Project No. 2035-099

Subject: Gross Reservoir Hydroelectric Project, FERC Project No. 2035. Denver Water's response to FERC's February 1, 2017 letter requesting additional information on its License Amendment Application filed on November 25, 2016.

## **ADDENDUM TO RECREATION MANAGEMENT PLAN (ARTICLE 416)**

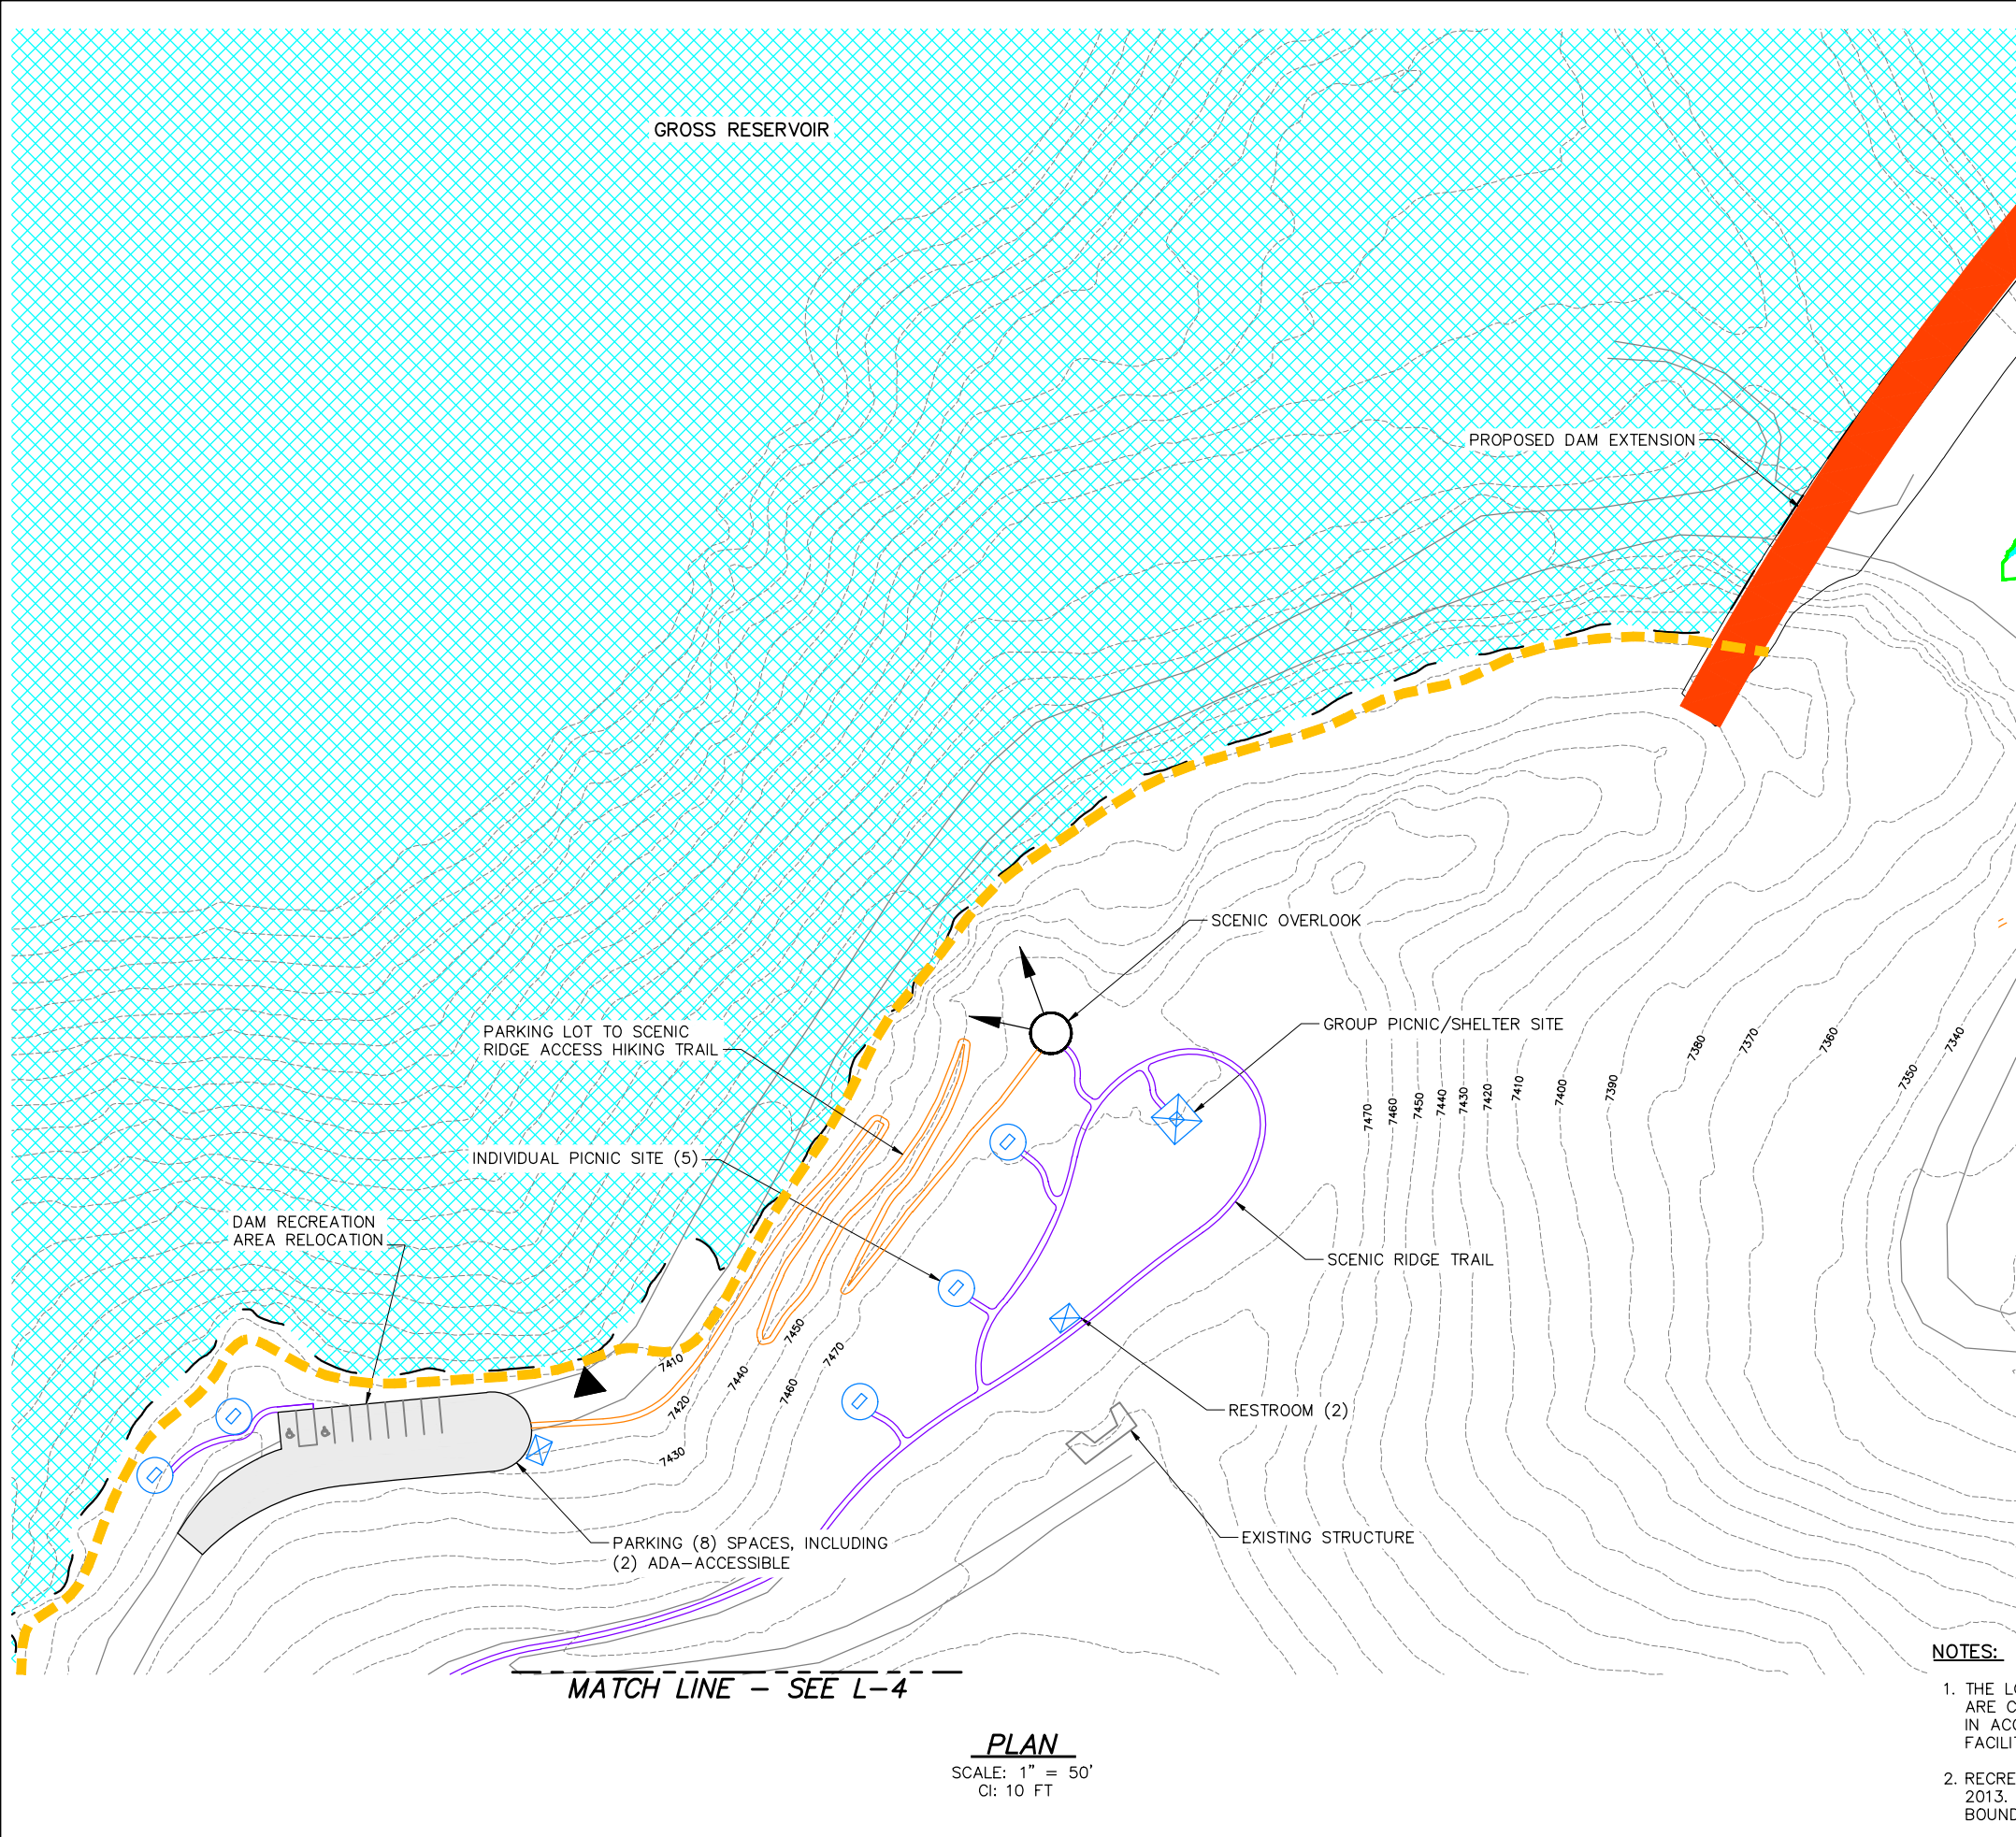
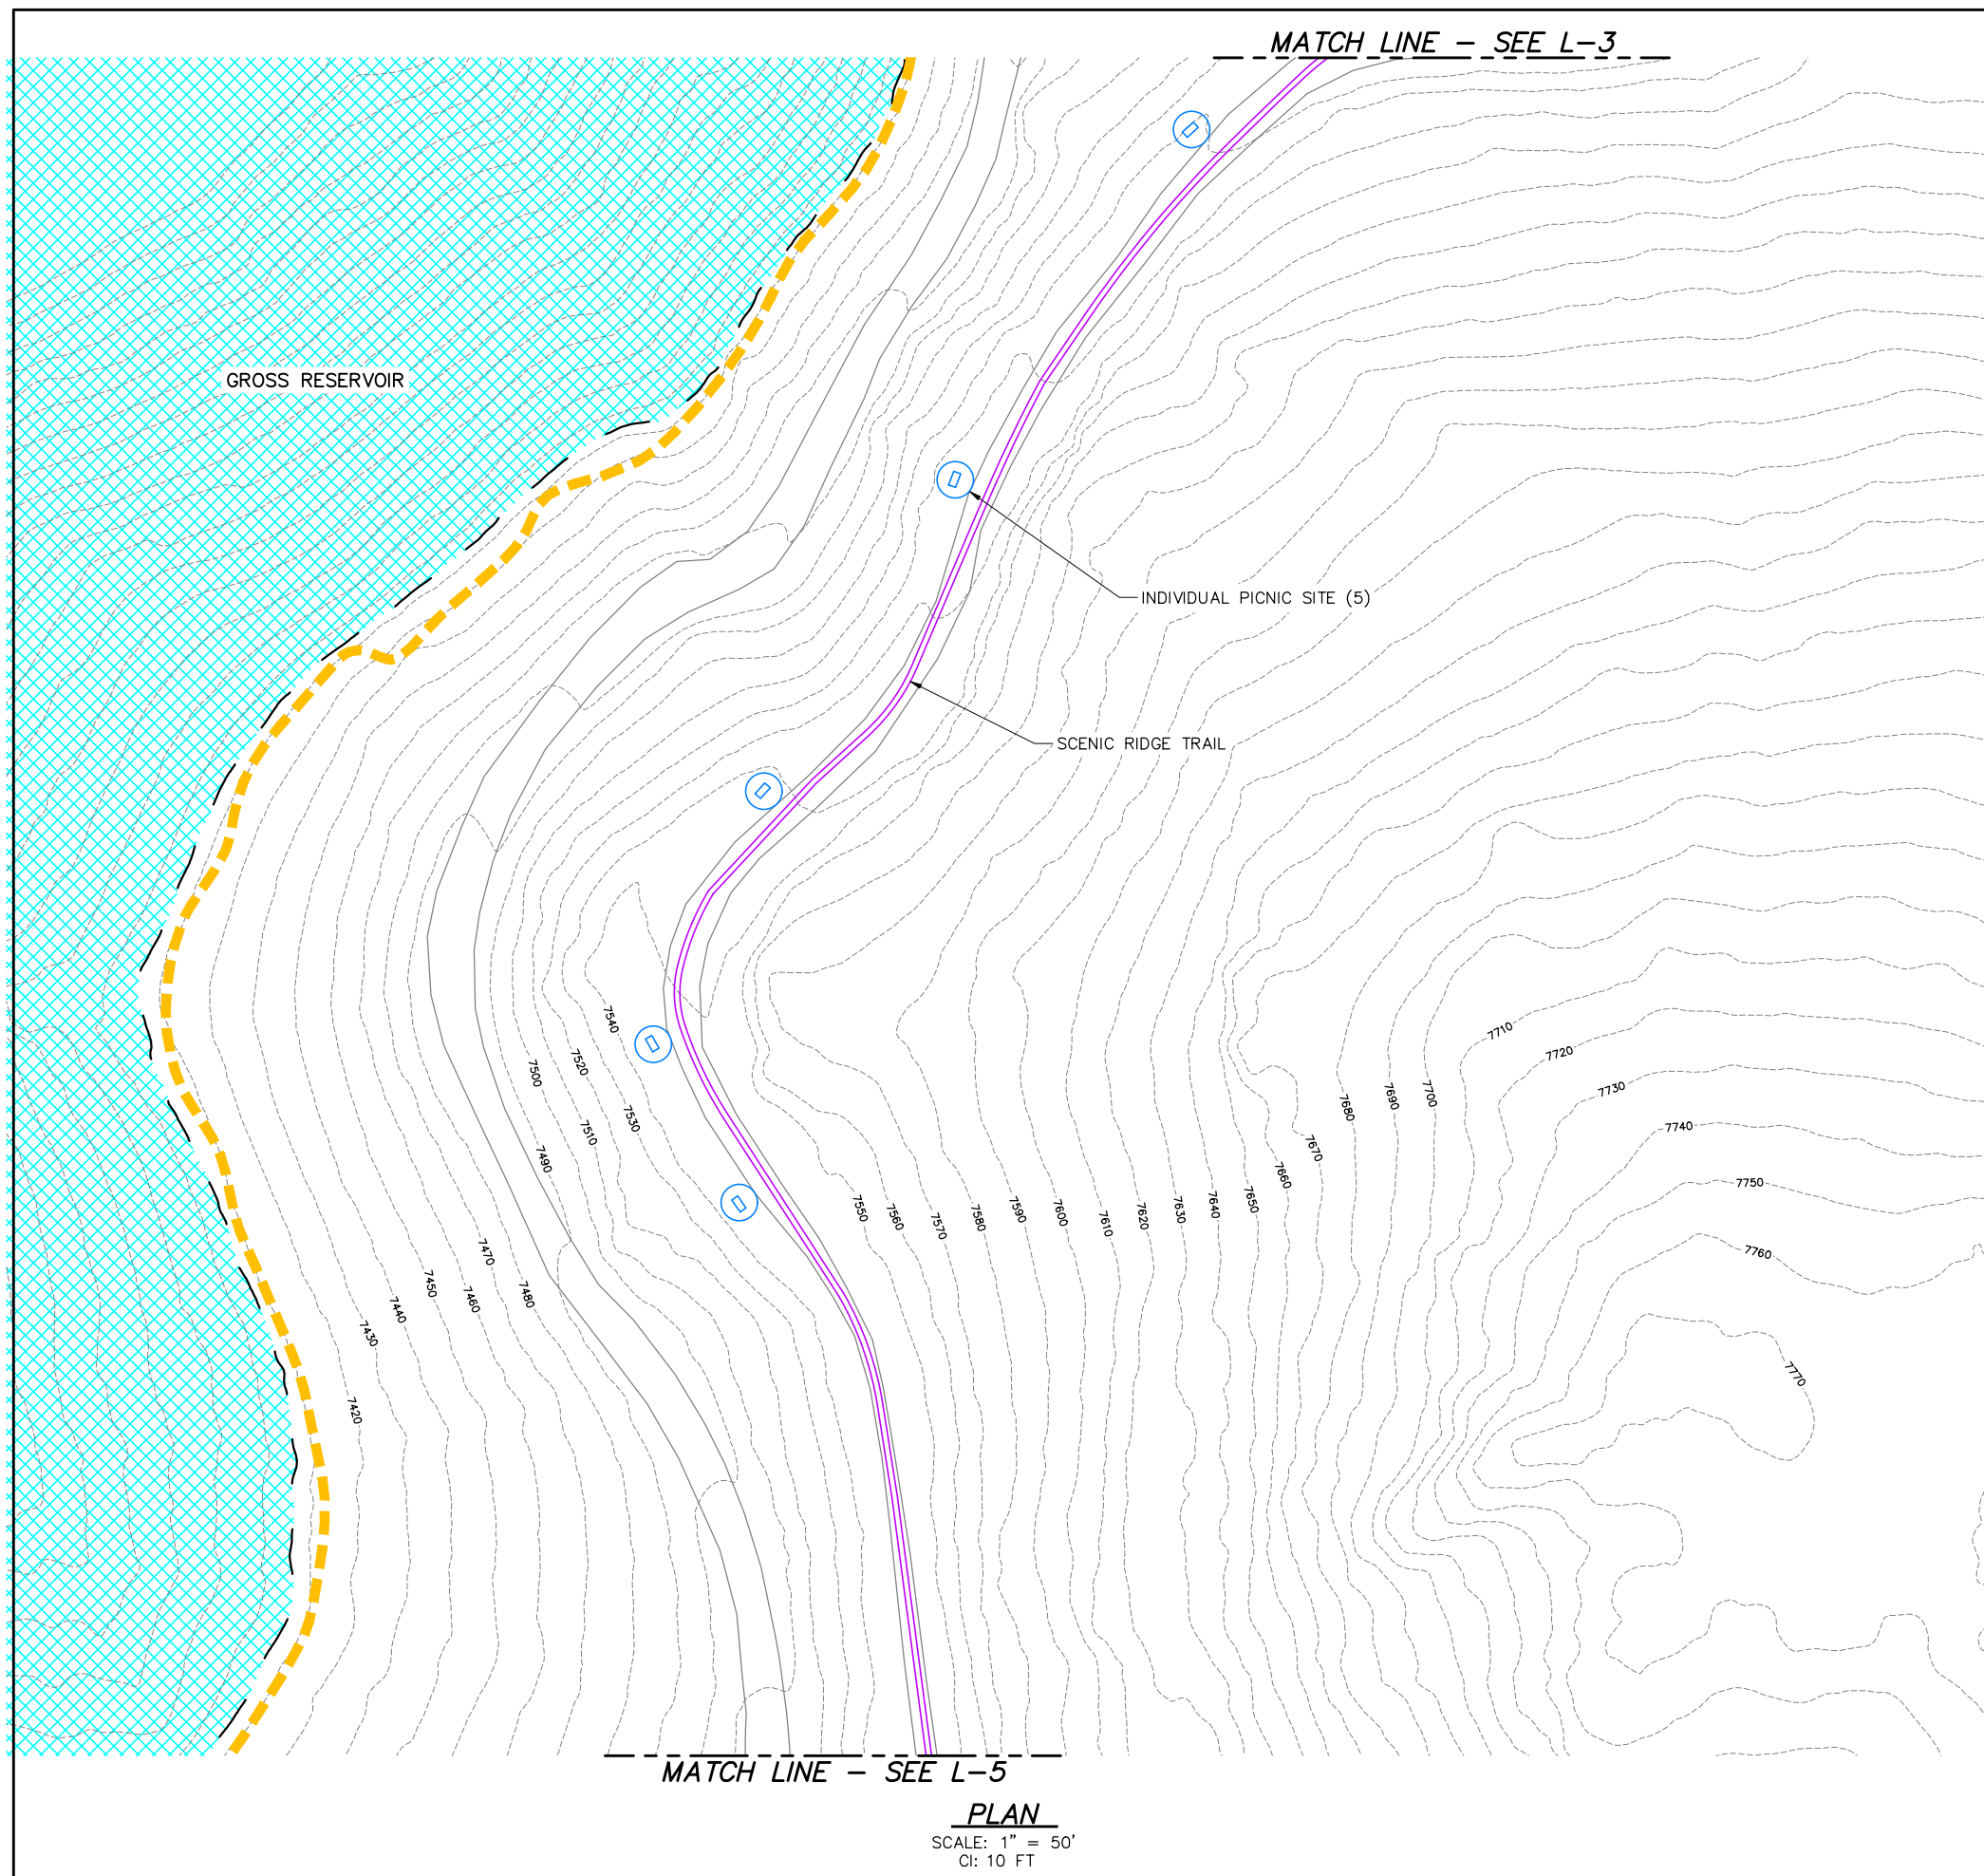
5. **Access to proposed Scenic Ridge Trail. Please clarify whether and how recreationists would access the proposed Scenic Ridge Trail from the northern-most parking area of the proposed Dam Recreation Area Relocation (see sheet L-3 of the recreation plan addendum). A path at this site seems appropriate; otherwise, the parking area only appears to provide access to two individual picnic sites and a fishing access.**

# Gross Reservoir Recreation Facility Usage Counters Proposed Summer 2017

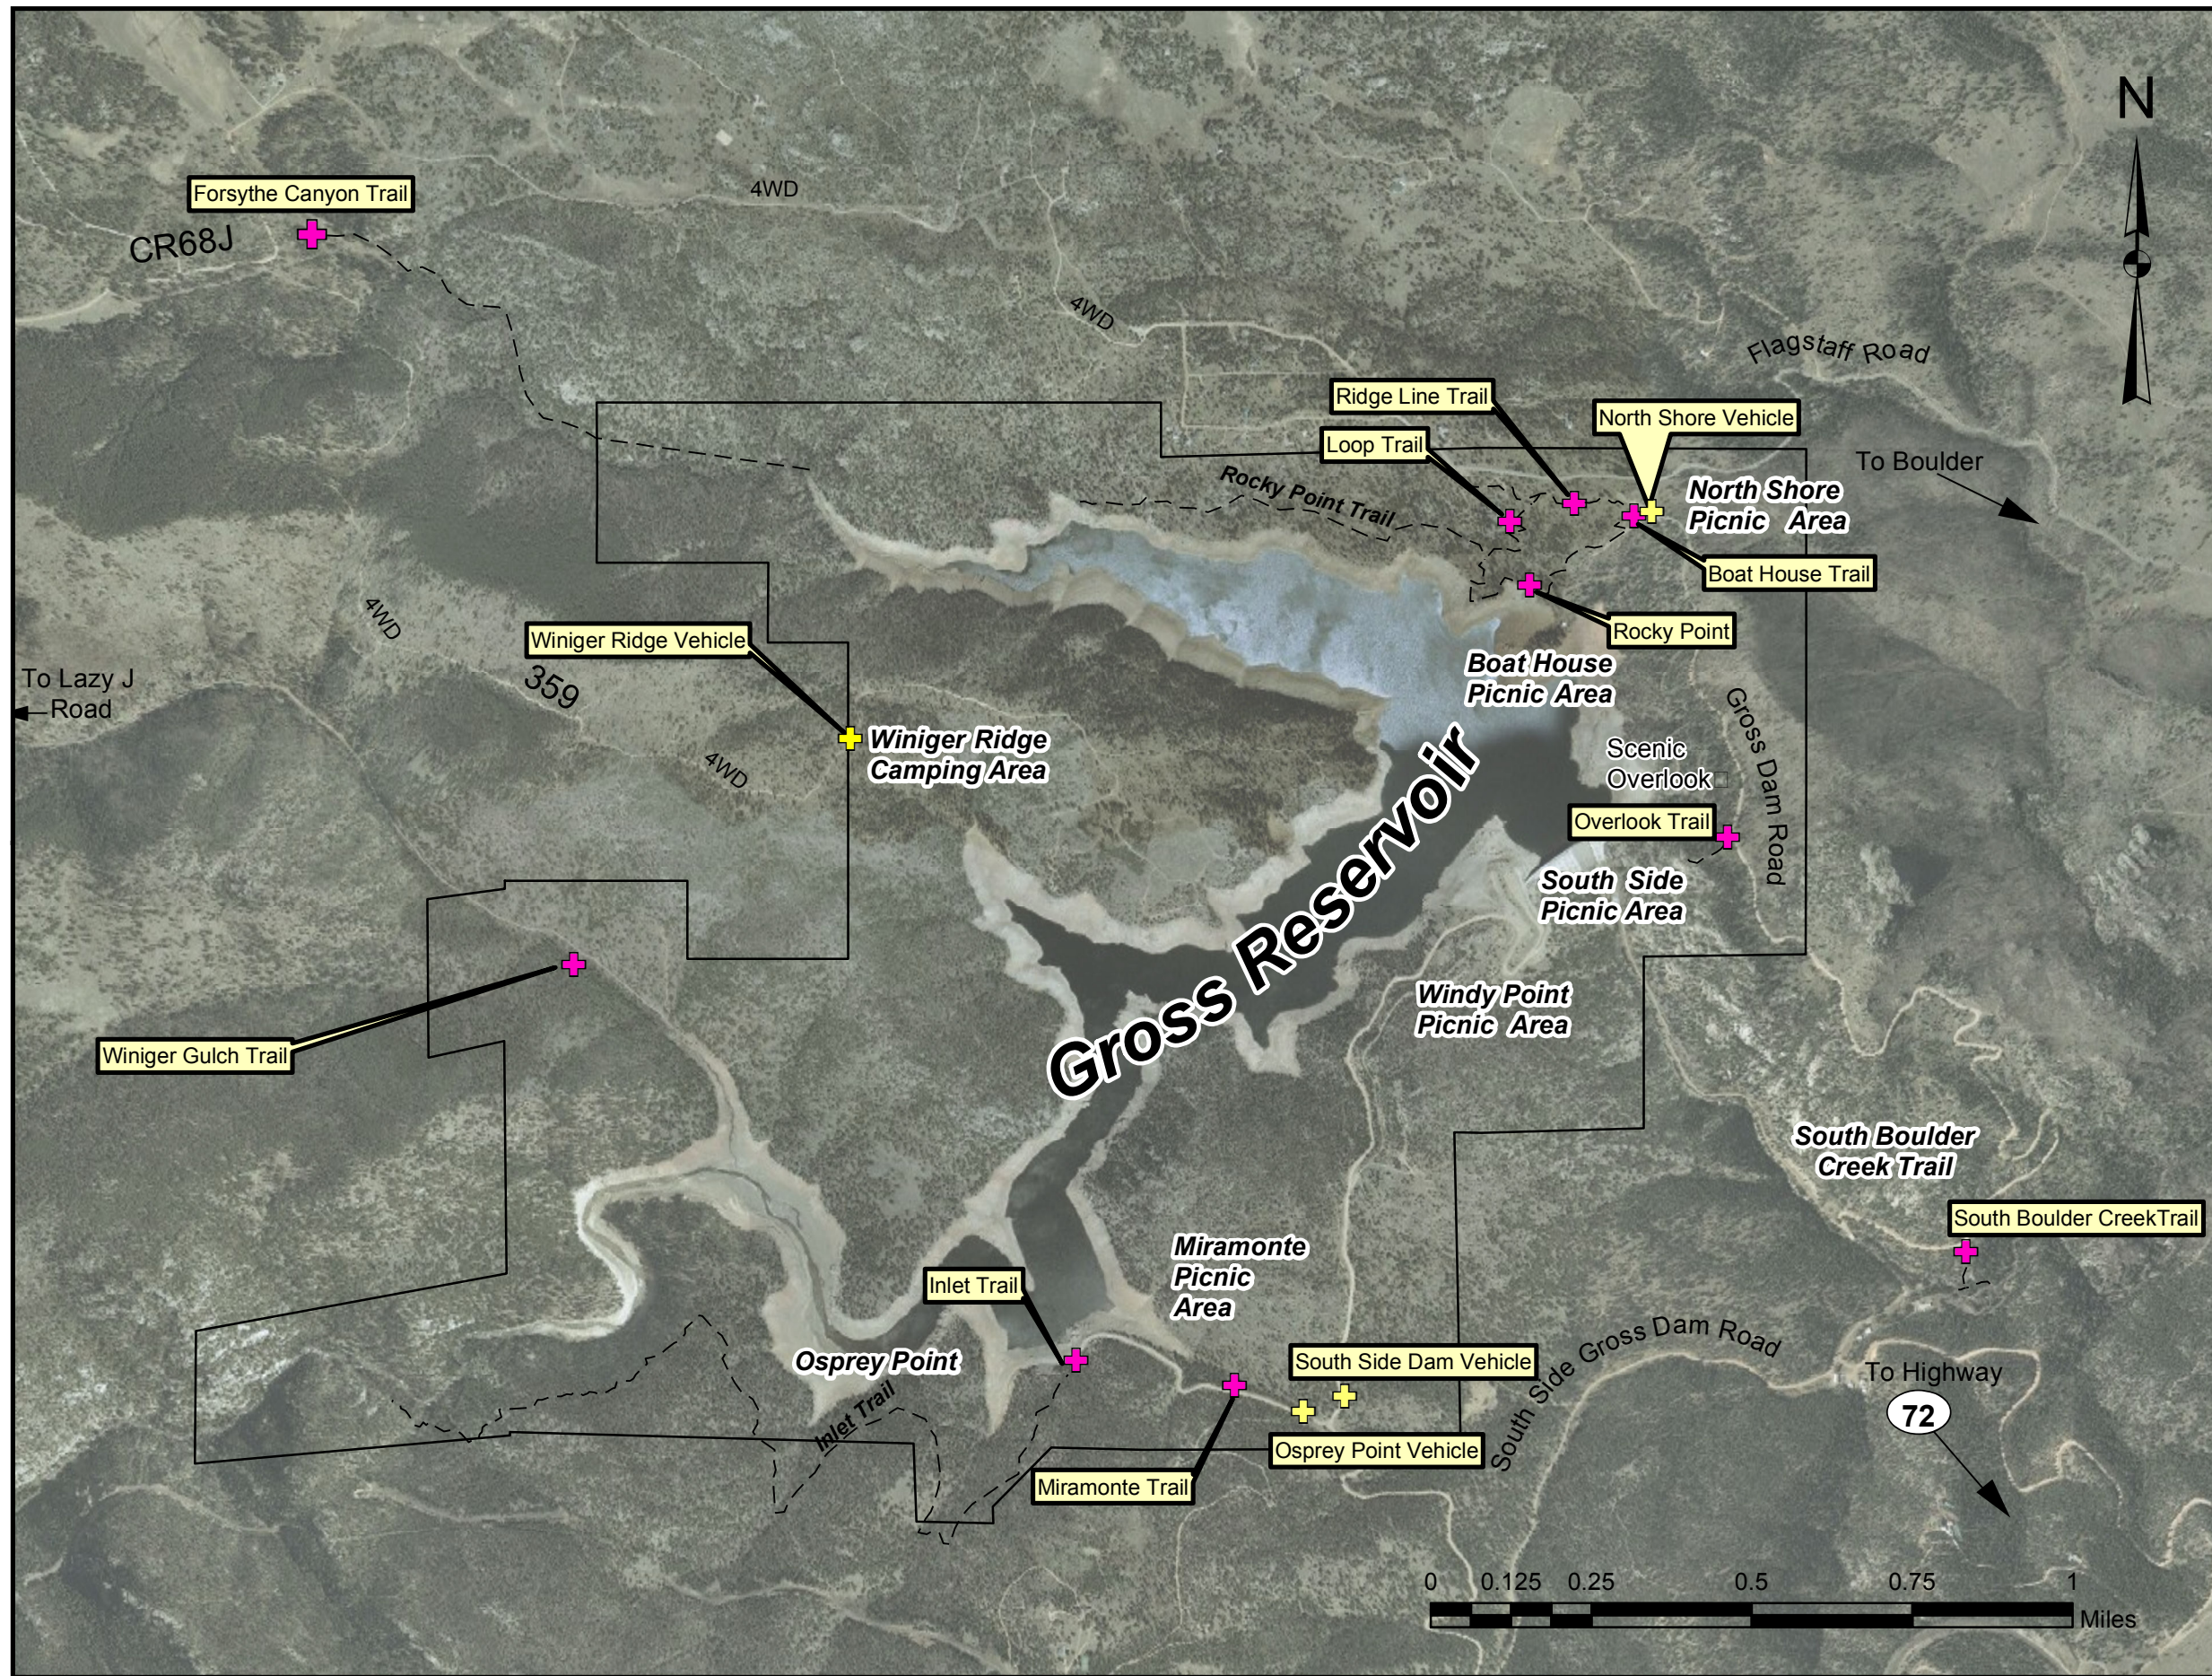
Denver Water's future plans to collect and maintain recreational user data will include the installation of several more trail and vehicle counters. Denver Water will be installing two additional vehicle counters and five more trail counters to bring the total to 11 counters at Gross Reservoir. This will help Denver Water's recreation staff to monitor daily use numbers which can be compiled by season and/or annually. See **Attachment 3** for a map of the locations of the planned future counters.
